**ROCKY MOUNTAIN ARSENAL
NORTH BOUNDARY SYSTEM COMPONENT
RESPONSE ACTION ASSESSMENT**

**FINAL TECHNICAL PLAN
MAY 1988
CONTRACT NUMBER DAAK11-84-D-0016
TASK NUMBER 36**

Final Technical Plan
(Version 3.2)

Figure 3.1-2
 PROPOSED SITES FOR NEW MONITOR WELLS
 AND BOREHOLES FOR TASK 36

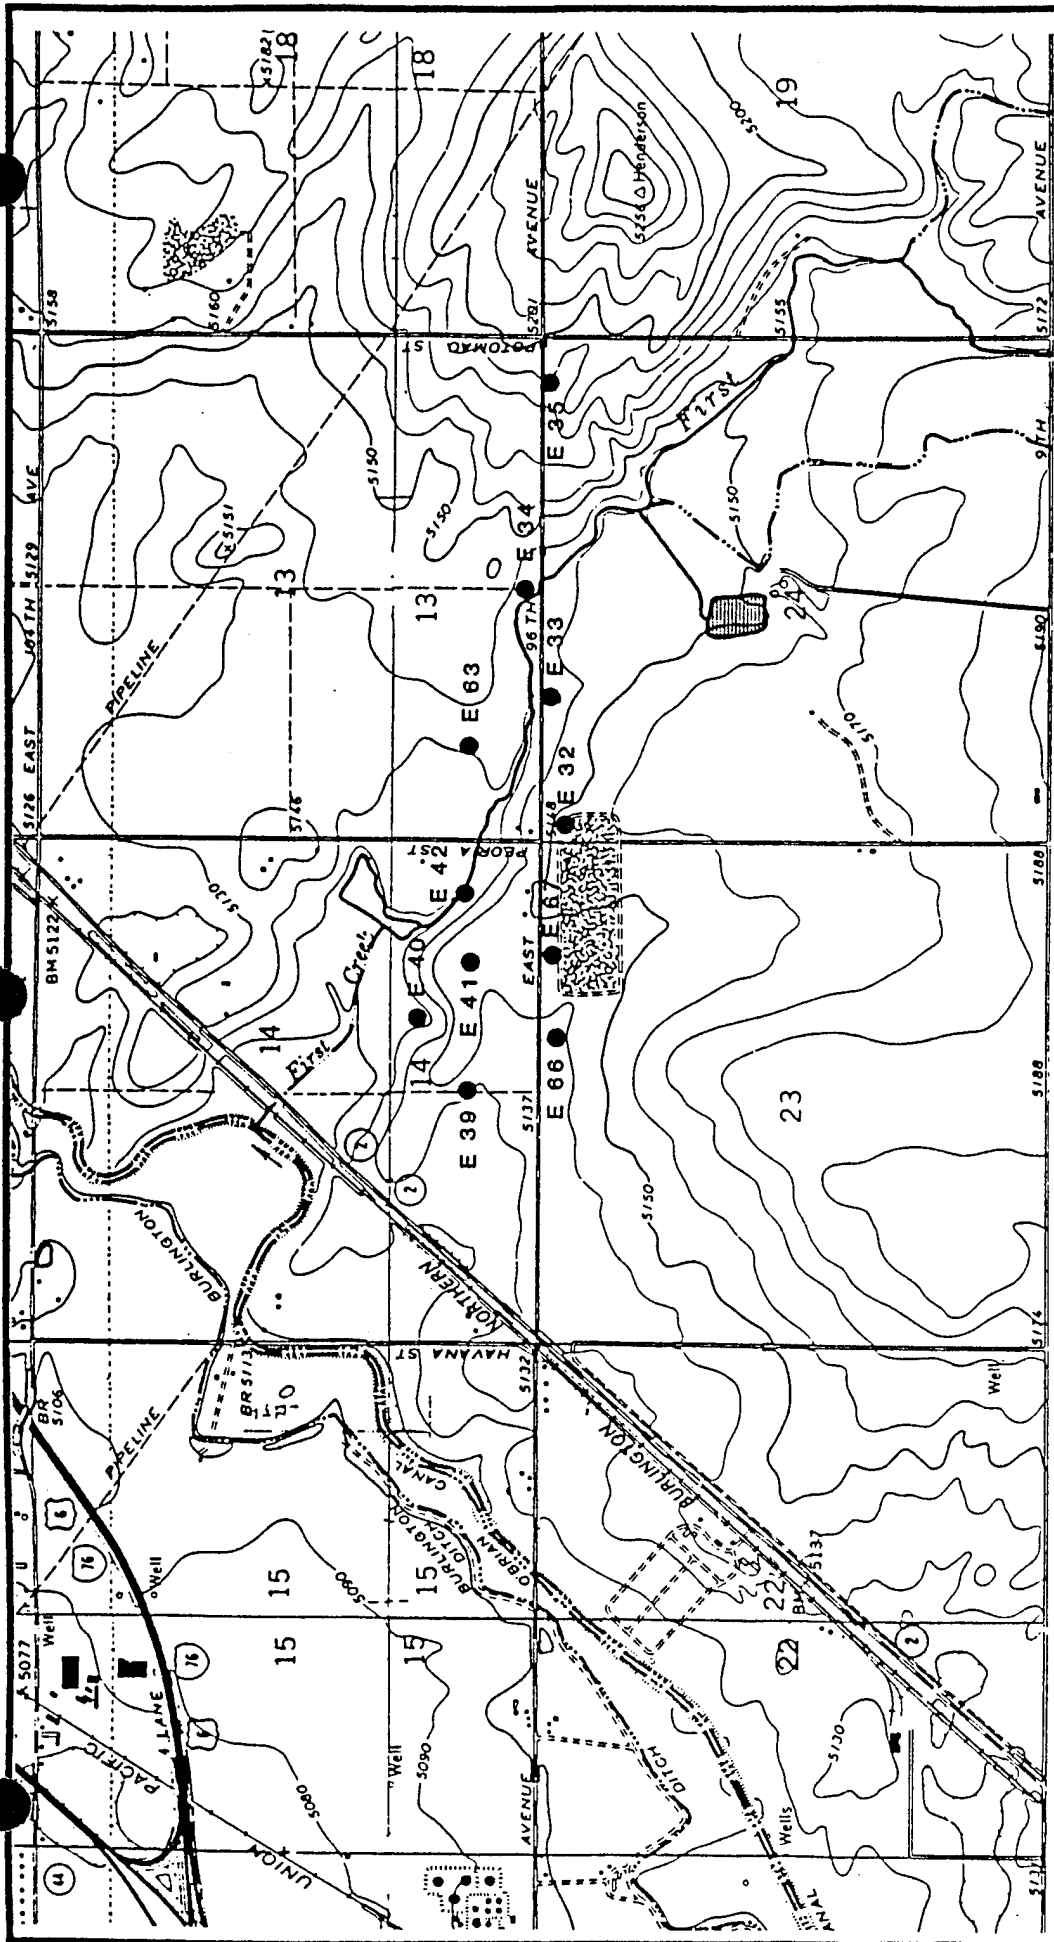
Response: In addition to the wells identified in Figure 3.1-2 of the Draft Final Technical Plan, several additional sites have been drilled or are being considered for drilling on the west side of the NBCS. These sites are identified in the Draft Final of the Comprehensive Drilling program. Table 1 shows a listing of additional well sites, their locations, the types of sites, their status, and under which task they are being installed.

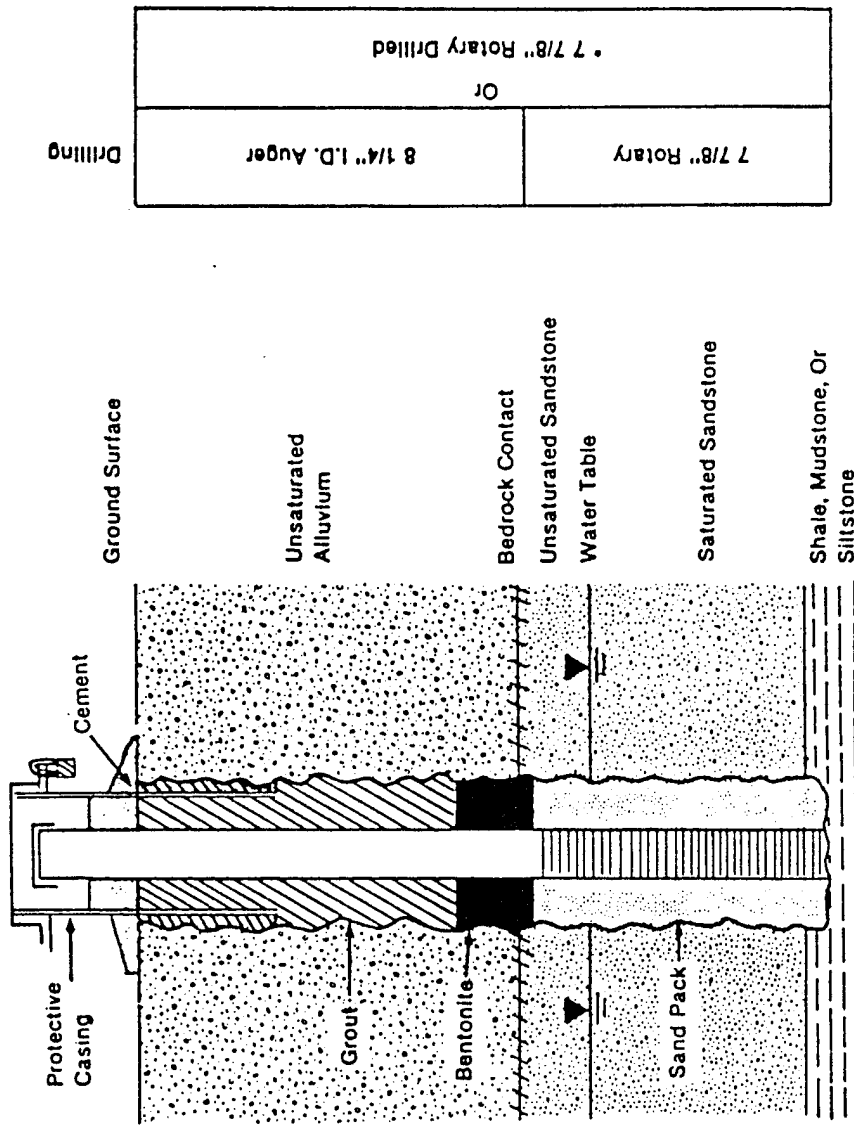
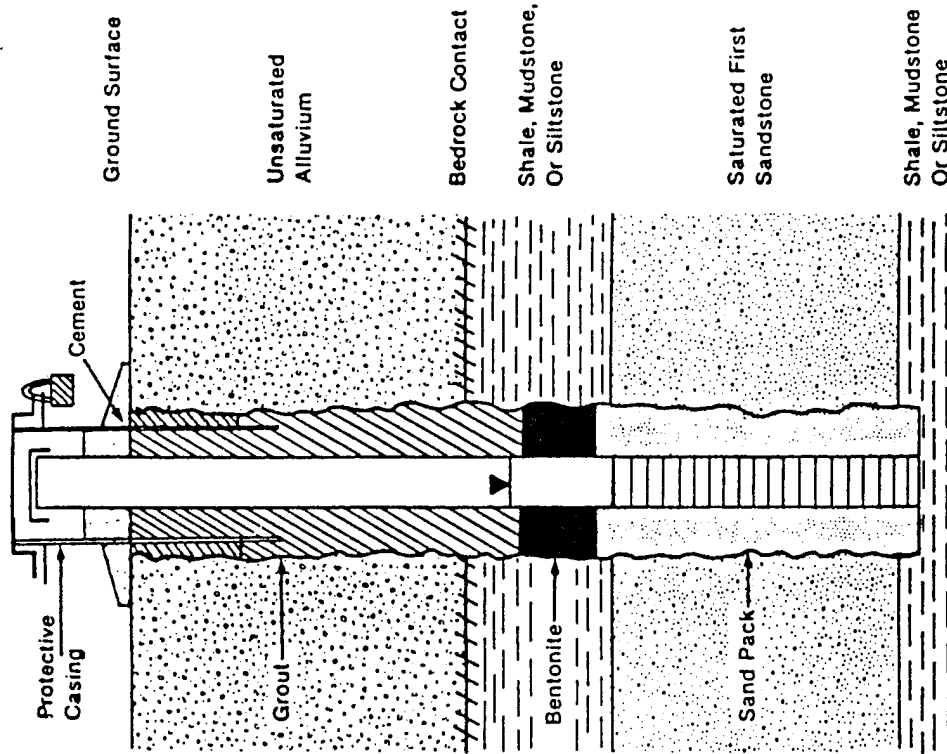
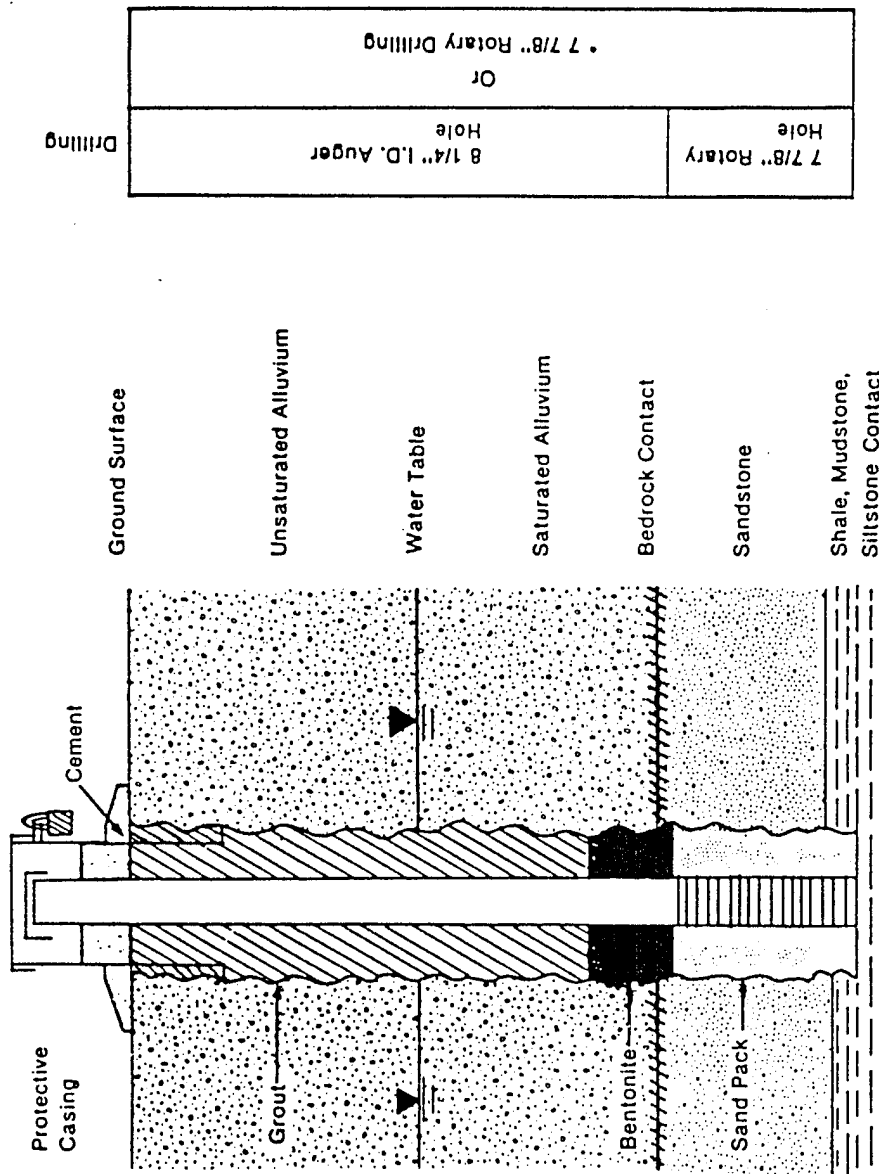
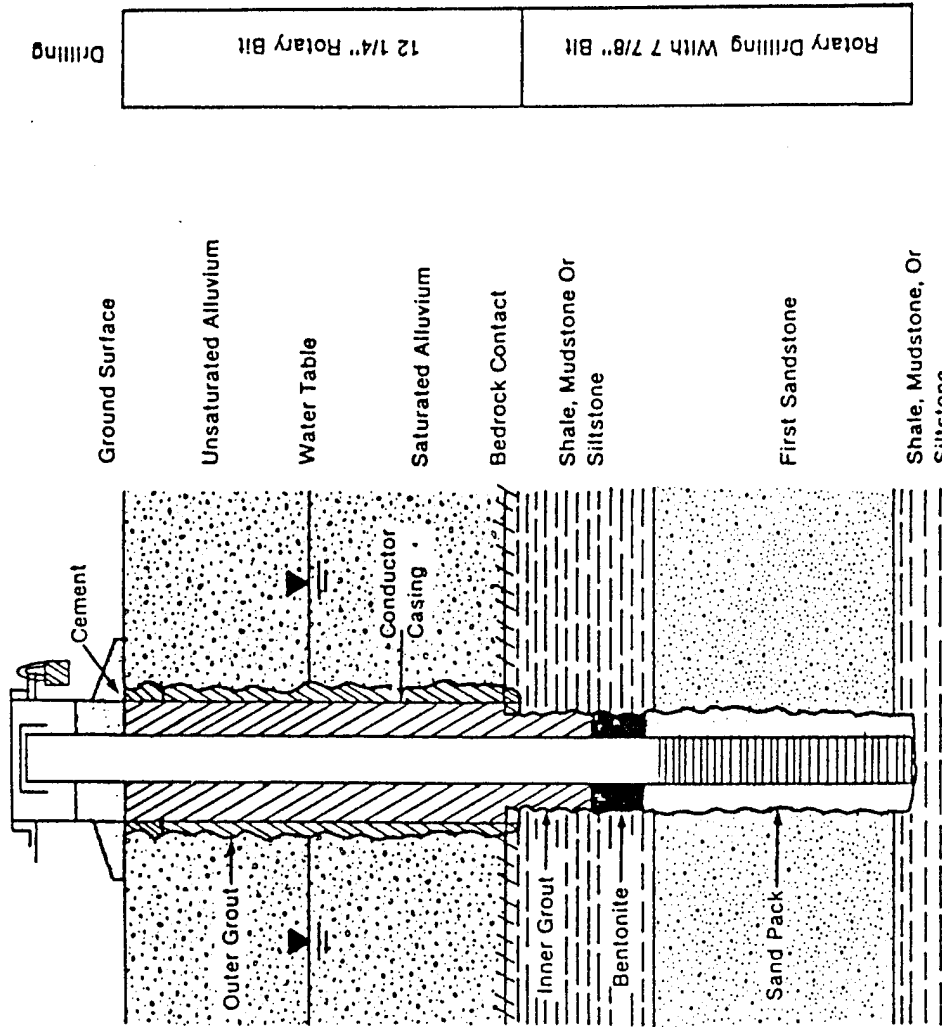
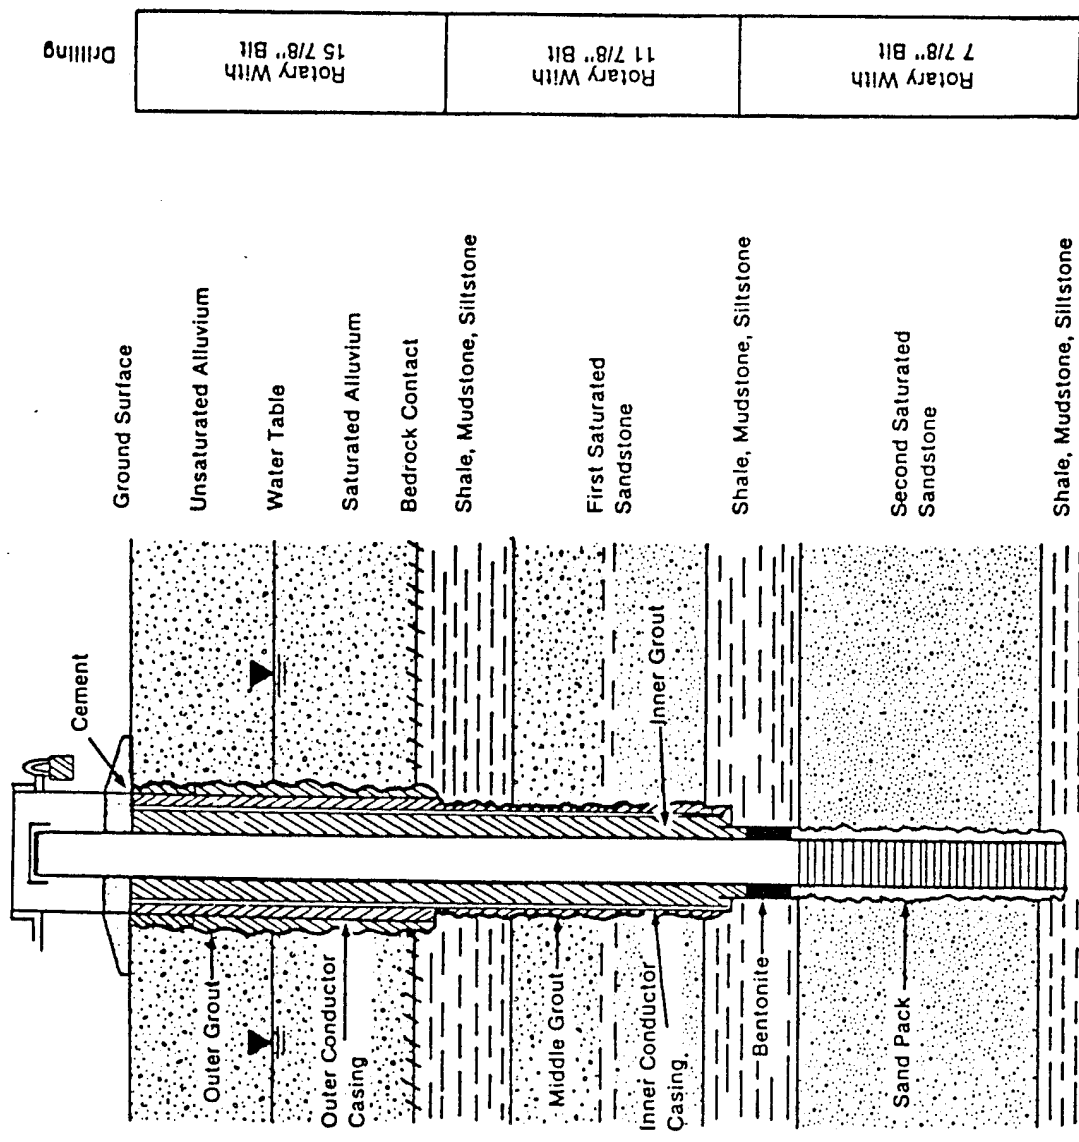
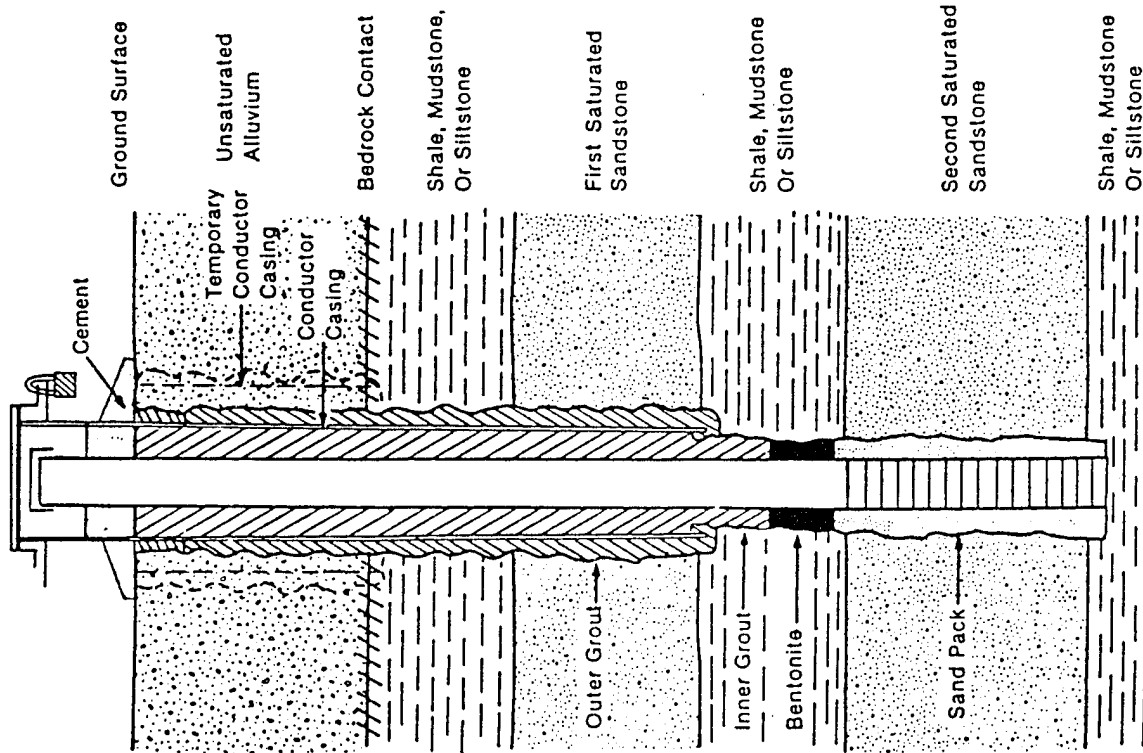
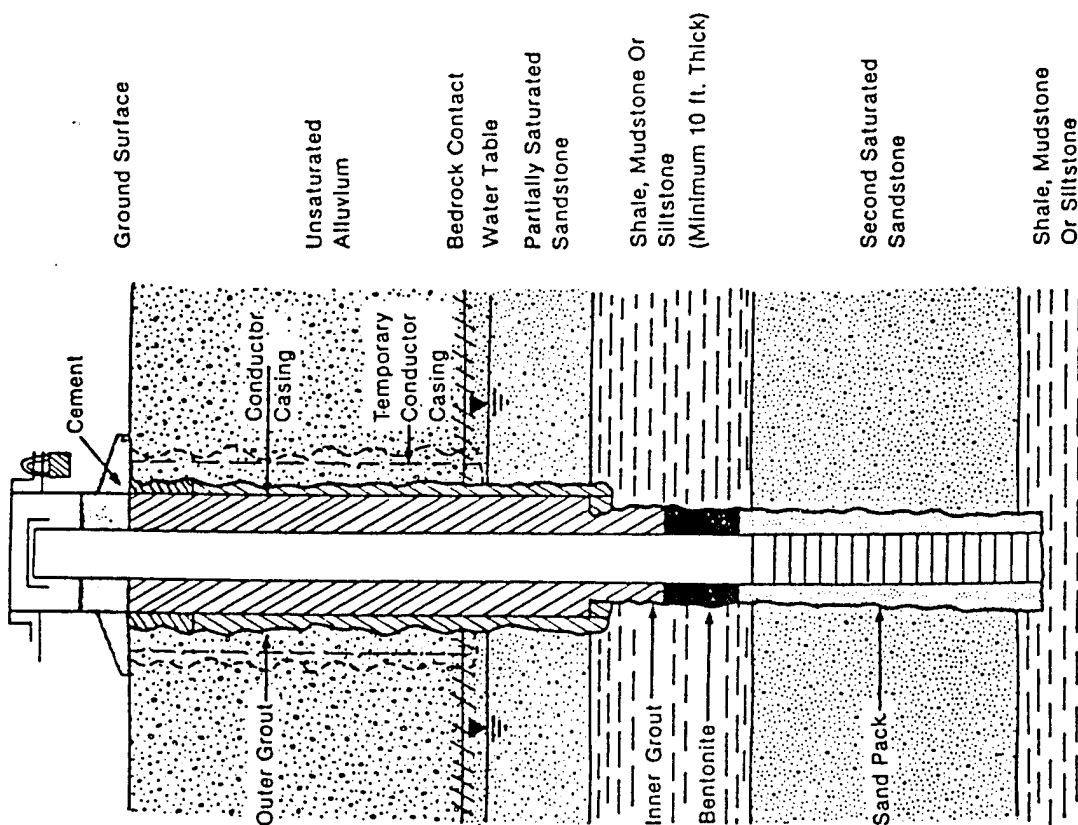
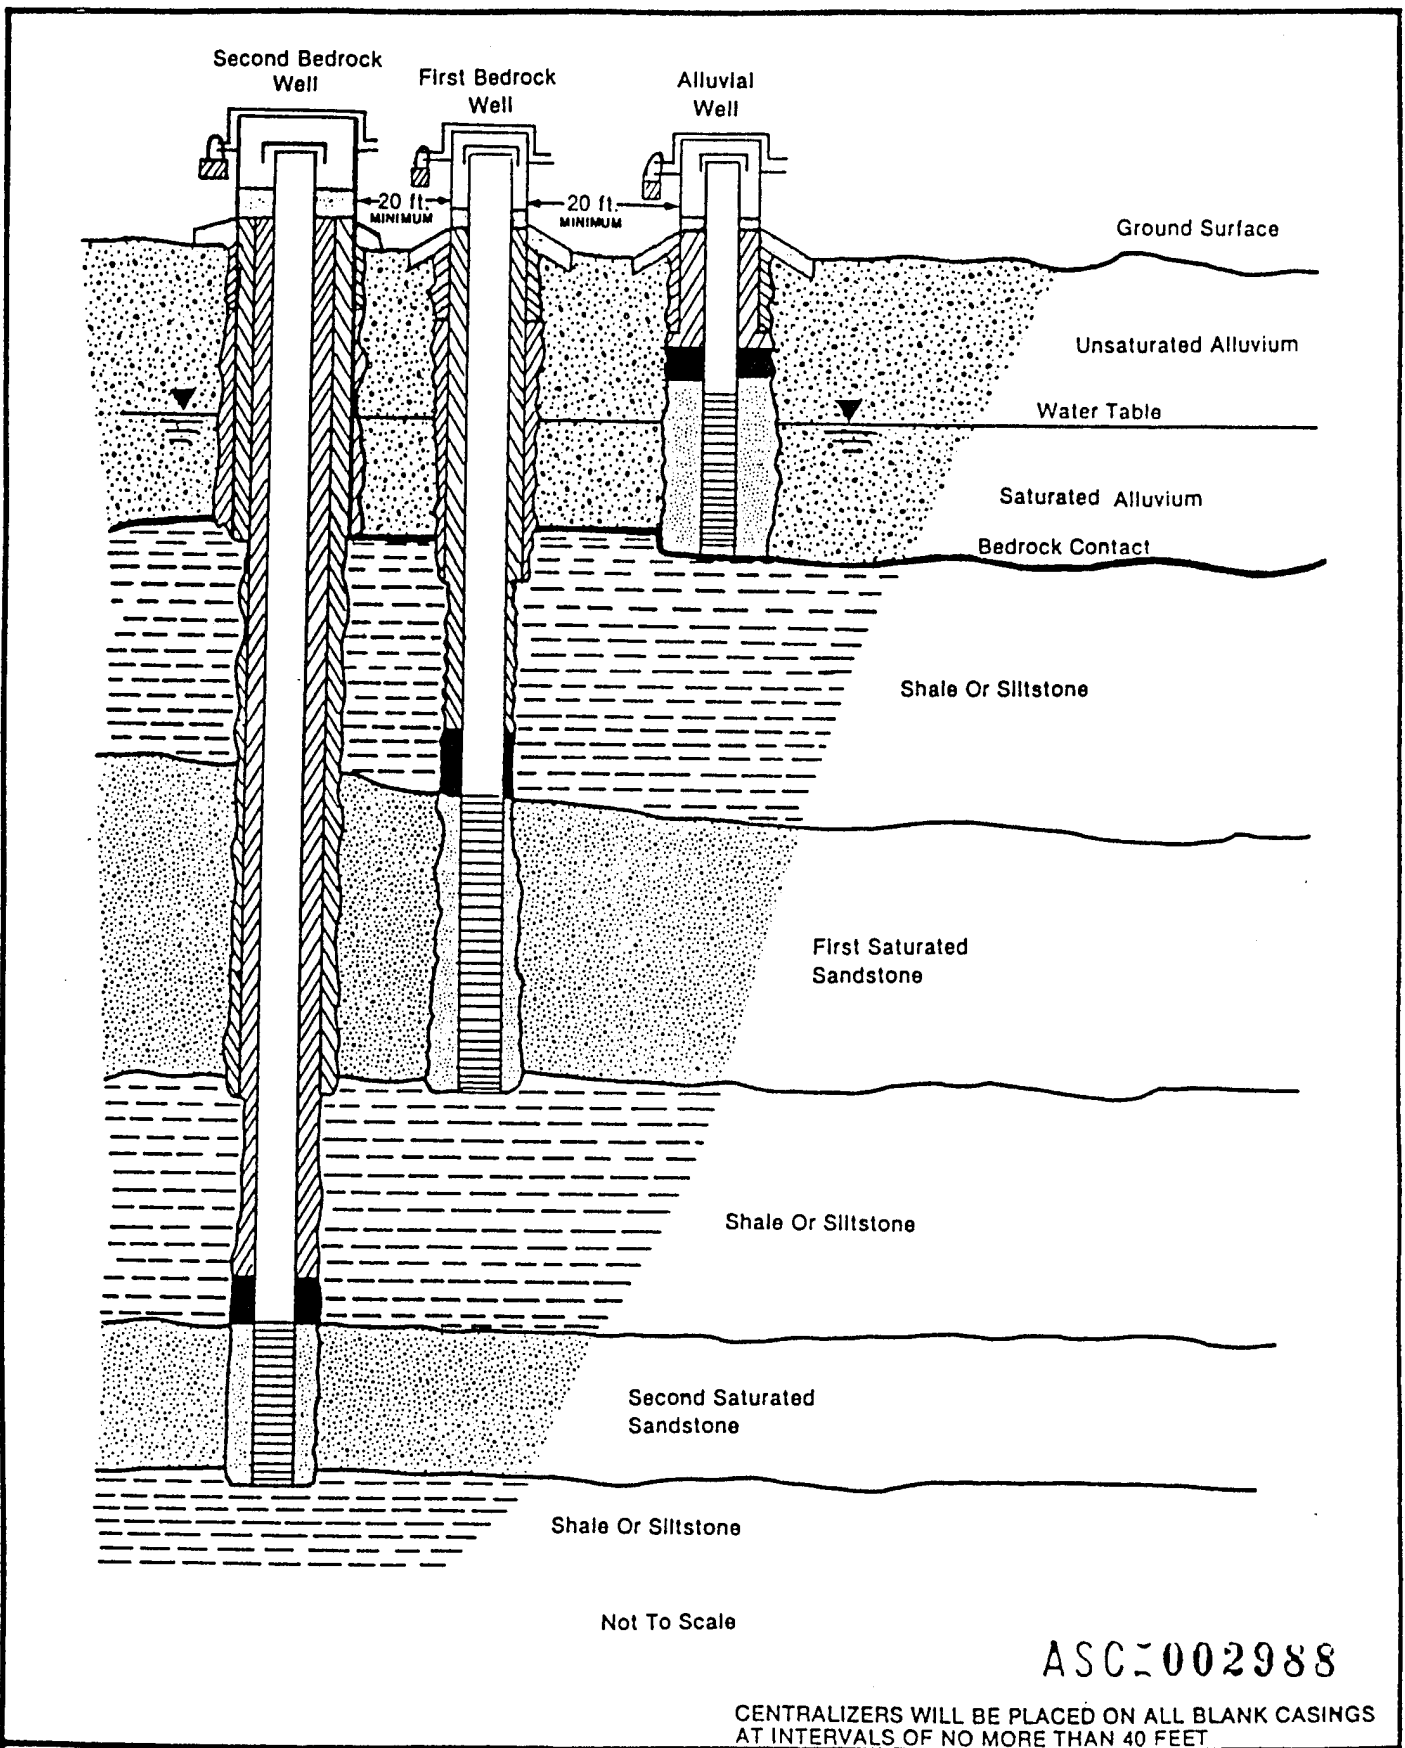
Figures 3.2-2a through 3.2-3. Construction details and contingencies for installing monitoring wells in shales/claystones of the Denver aquifer that show evidence of fracturing must be included in the technical plan.
